Access Compliance Report Public Rights-of-Way (Curb Ramps)

Intersection ID: 44911 Main Street: FOX POINT DR **Cross Street: SPRINGHAVEN DR** Location: W

ADA ID: 1D40273A1A79 Ramp Type: Perp Initial Pass/Fail: Pass **Overall Compliance: No Severity Score:** 7.75

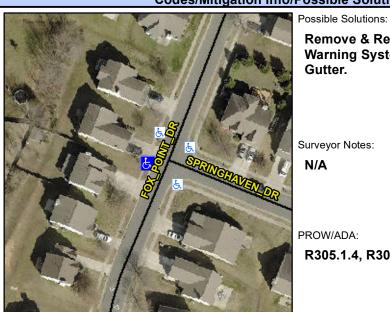
Remove & Replace Detectable Warning System. Remove & Replace Gutter.

R305.1.4, R304.5.4
